STAFF REPORT
COMMUNITY DEVELOPMENT DEPARTMENT

HEARING DATE: October 3, 2024
 TO: Planning & Zoning Commission
 FROM: Stacy Hersh, Associate Planner
 208-884-5533
 SUBJECT: The Gateway at Ten Mile PP, CUP
[H-2024-0010](#)
 LOCATION: NEC of W. Franklin Rd. & N. Ten Mile Rd., in the West ½ of the SW ¼ of Section 11, Township 3N., Range 1W. (Parcel: S1211336065)

Preliminary plat (PP) consisting of 31 buildable lots 3 common lots on 38.99+/- acres of land zoned C-G and R-40 for The Gateway at Ten Mile; and a Conditional use permit (CUP) for a multi-family development containing a total of 390 residential dwelling units in the R-40 zoning district.

PP1.0

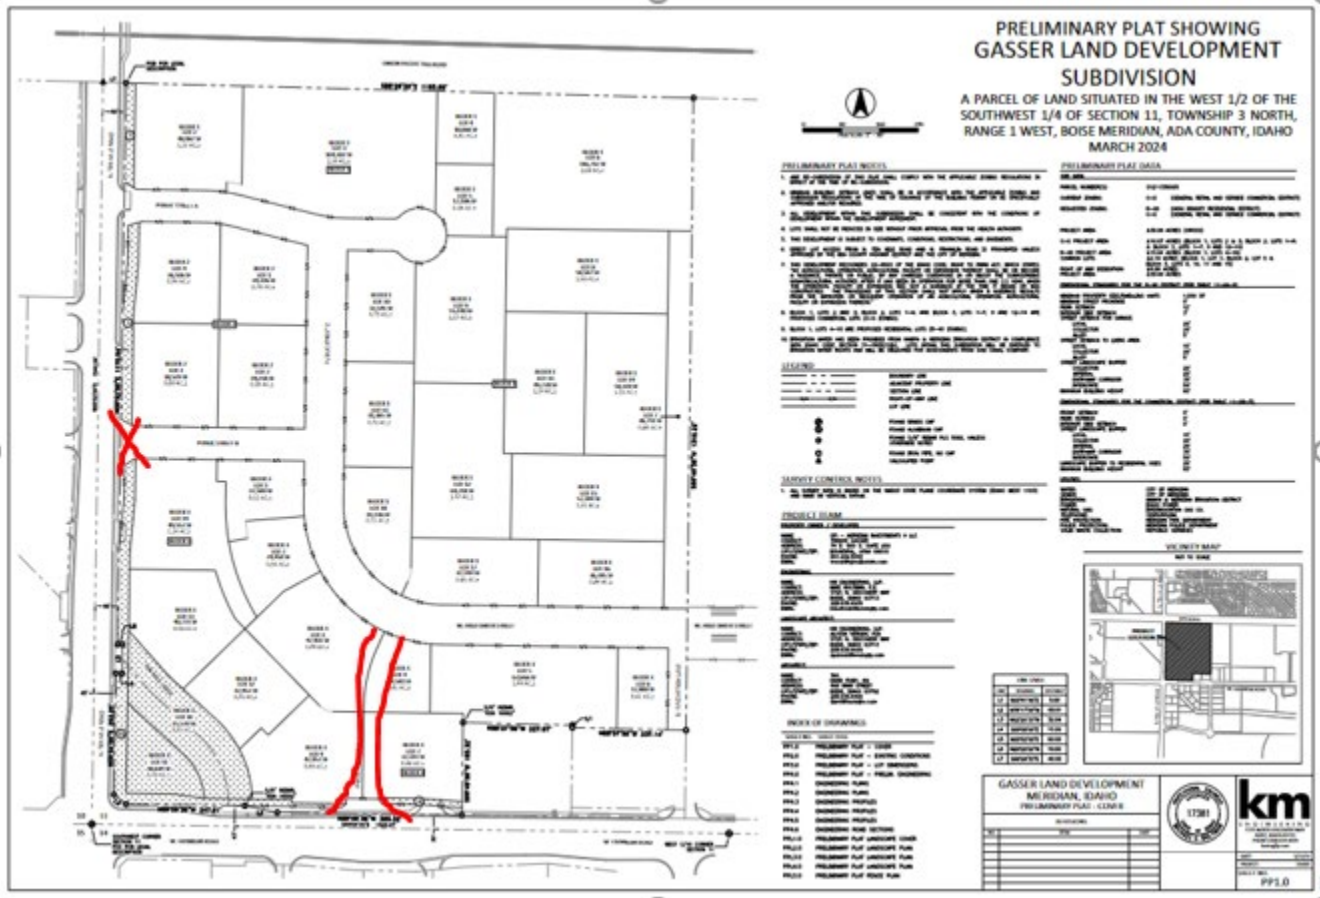
A preliminary plat (PP) consisting of 31 buildable lots on 38.99+/- acres of land in the C-G and R-40 zoning districts is proposed for The Gateway at 10 Mile (see Section VIII.A). The Applicant has not yet submitted a phasing plan. Staff recommends that the Applicant provide, or be prepared to discuss a phasing plan at the public hearing. Additionally, the development agreement requires the Applicant to connect to W. Fred Smith Street from the east. Staff recommends that the plat illustrates the connection from the east.

Access is proposed via three roads: W. Franklin Rd., a commercial arterial; N. Ten Mile Rd., a residential mobility arterial; and the future extension of N. Wayfinder Avenue, a towncenter collector street designated as N. Innovation Lane on the plat. However, the Applicant inaccurately labeled the collector street as S. Innovation Lane on the plat, whereas S. Innovation Lane is located farther west across Franklin Road and functions as a local street. South Wayfinder Avenue lines up directly to the development's south across Franklin Road. **Staff recommends that the Applicant correct the name of the future collector street on the plat.**

with Private Street A. Staff recommends depicting Private Street A as a drive aisle on the plat because it does not meet the private street standards outlined in UDC 11-3F-4.

The Applicant proposes extending W. Fred Smith Street from east to west, then turning into Public Street C heading north. *The Applicant should connect into Fred Smith Street from the east and construct Street C and Fred Smith Street as a 36-foot wide local commercial street sections with 2-travel lanes, parking on both sides of the roadway, vertical curb, gutter, and bulb-outs at intersections and pedestrian crossings with an 8-foot planter strip and 10-foot wide multi-use pathways on both sides of the roadway.*

- b. The extension of N. Wayfinder Avenue on the east property boundary shall be included in the construction drawings for the first phase of development; or, may be included in a separate submittal to ACHD. **Replace S. Innovation lane with N. Wayfinder Avenue on the plat.*

- h. Remove Public Street B from the plat limiting the number of access points on a busy arterial street near the intersection per UDC 11-3A-3.
 - i. Depict a cross-access easement on Lots 3 – 9, Block 3 for the right-in/right-out drive aisle on the plat.

sides of the roadway, vertical curb, gutter, and bulb-outs at intersections and pedestrian crossings with an 8-foot planter strip and 10-foot wide multi-use pathways on both sides of the roadway on the plat.

- m. Lot 10, Block 3 shall remain preserved for the Ten Mile Creek and associated easement.
 - n. Add a note to the plat requiring cross-access for all lots that do not have access to a public street.

B. Landscape Plan (date: 03/11/2024)

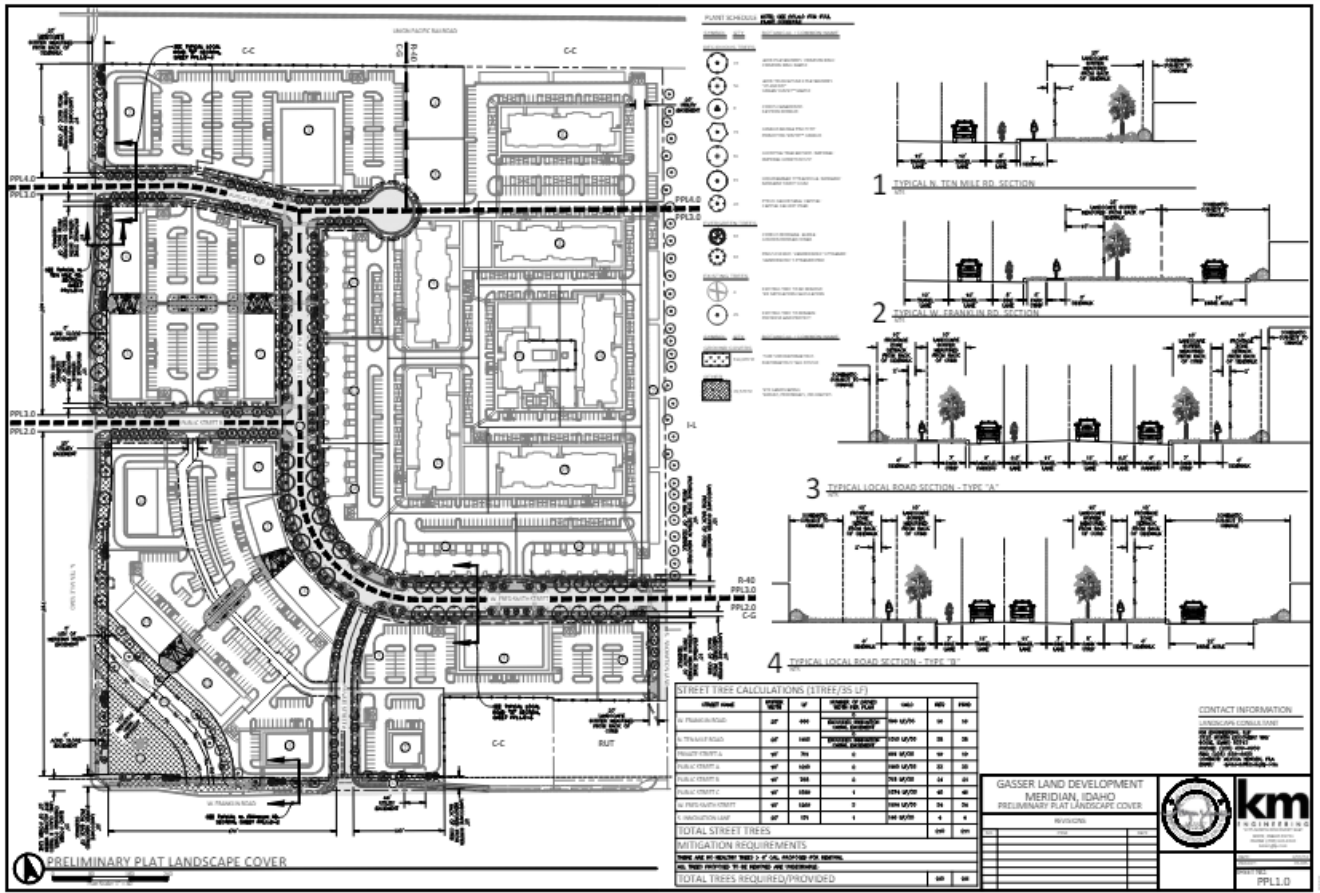
The number of trees proposed in buffers meets the minimum standard required by UDC 11-3B-7; however, the TMISAP requires an enhanced street buffer to align with the TM Center Subdivision directly to the south. (refer to figure below). Furthermore, Staff finds that the Applicant should enhance the landscaping around the Ten Mile Creek on Lot 10, Block 3 to create an attractive linear open space for the development.

A calculations table is included on the landscape plan submitted with this application demonstrating compliance with the above standards; however, Staff recommends that the applicant enhance the street buffers in accordance with the TMISAP guidelines (pages 3-26, 3-27, 3-28, 3-29 & 3-30.

Fencing (UDC [11-3A-7](#)): A 6' privacy fence is proposed on the north and west side of the multi-family development. *Staff recommends that the Applicant submit a detail of the fencing at the time of CZC submittal.*

- b. Include a detail of the proposed fencing at the time of CZC submittal.
 - c. Depict a minimum 5-foot wide detached sidewalk along S. Ten Mile Rd. in accord with UDC [11-3A-17A](#).

D. Pedestrian & Bicycle Circulation Plan

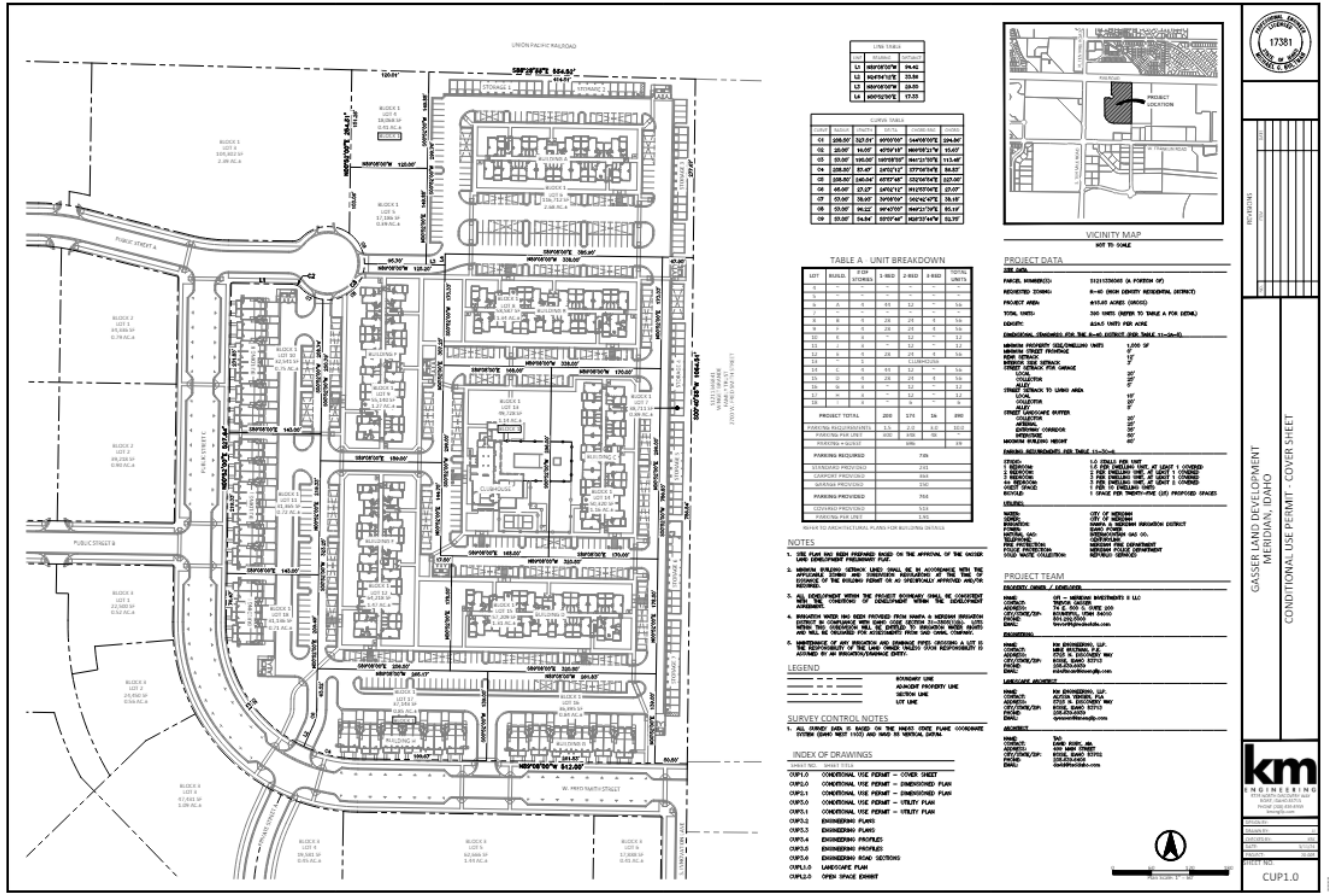
The Applicant is proposing what appears to be 6-foot wide sidewalks along both sides of W. Fred Smith Street and Public Street C. **Staff recommends that the Applicant construct 10-foot wide detached pathways along both sides of these streets in accordance with ACHD's adopted Livable Street Performance Measures and UDC 11-3A-5.**

West Ada School District (WASD) recommends the addition of a micro-path from the plaza area between Street A and Street B to the sidewalk along Ten Mile Road. This location would be a prime location for a bus stop.

E. Site Plan For Multi-Family Portion Of Development (date: 03/11/2024)

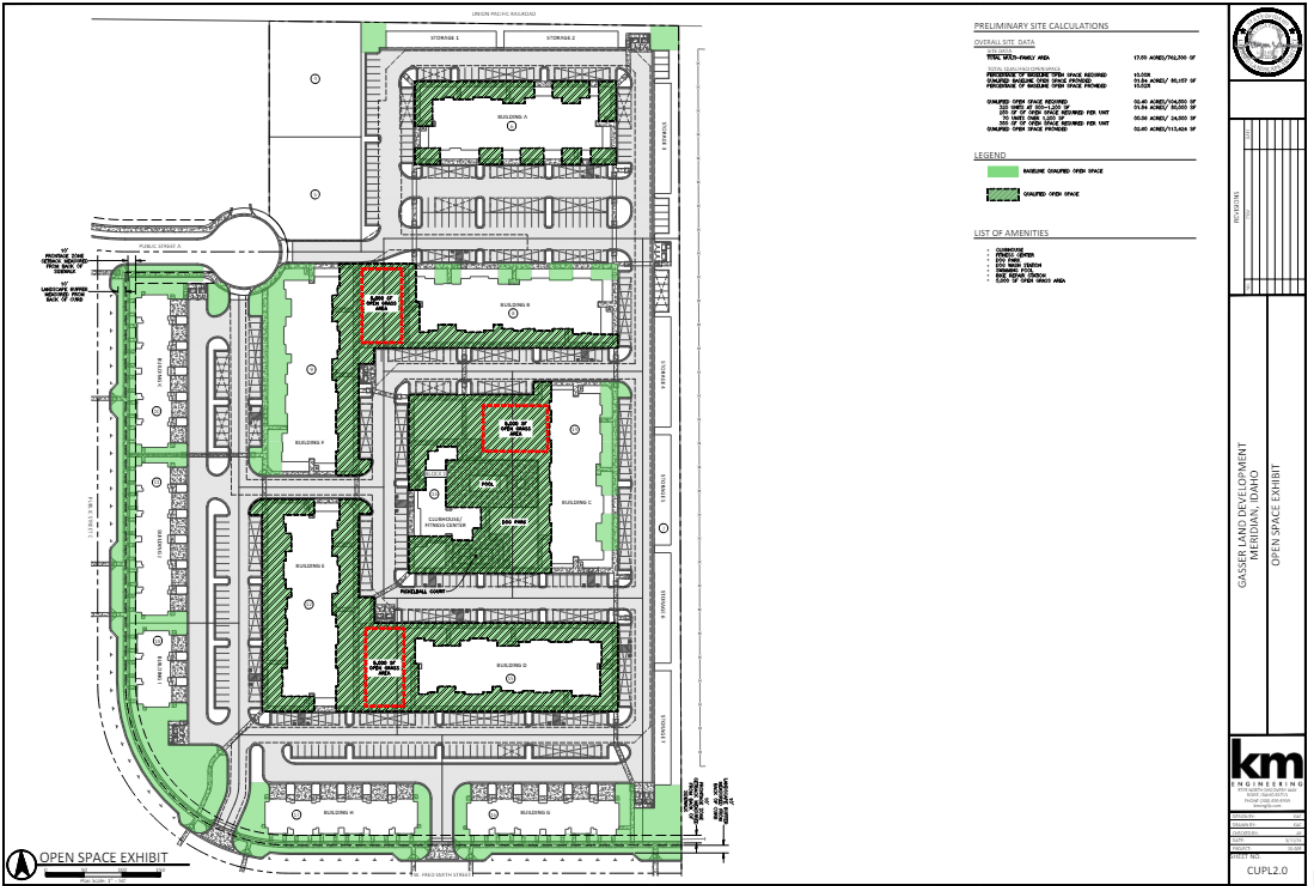
- c. A central mailbox location, including provisions for parcel mail, that provides safe pedestrian and/or vehicular access. *Located in clubhouse*
 - d. A directory and map of the development at an entrance or convenient location for those entering the development. *Depict on site plan*

All amenities are located within the central open space lot. The Applicant is proposing multiple amenities from the “Quality of Life” category, and missing an amenity from the “Open Space” category. The Applicant should add a picnic area that includes tables, benches, and a structure for shade in one of the open space grassy areas to meet the requirements of UDC Code 11-4-3-27.D for the site. Overall, the proposed amenities satisfy the required standards.

- a. Depict the locations of the property management office, maintenance storage area, central mailbox location (including provisions for parcel mail, that provide safe pedestrian and/or vehicular access), and a directory and map of the development at an entrance or convenient location for those entering the development in accord with UDC 11-4-3-27B.7.

- d. Add a picnic area that includes tables, benches, and a structure for shade in one of the open space grassy areas to meet the requirements of UDC Code 11-4-3-27.D for the site at the time of CZC submittal.
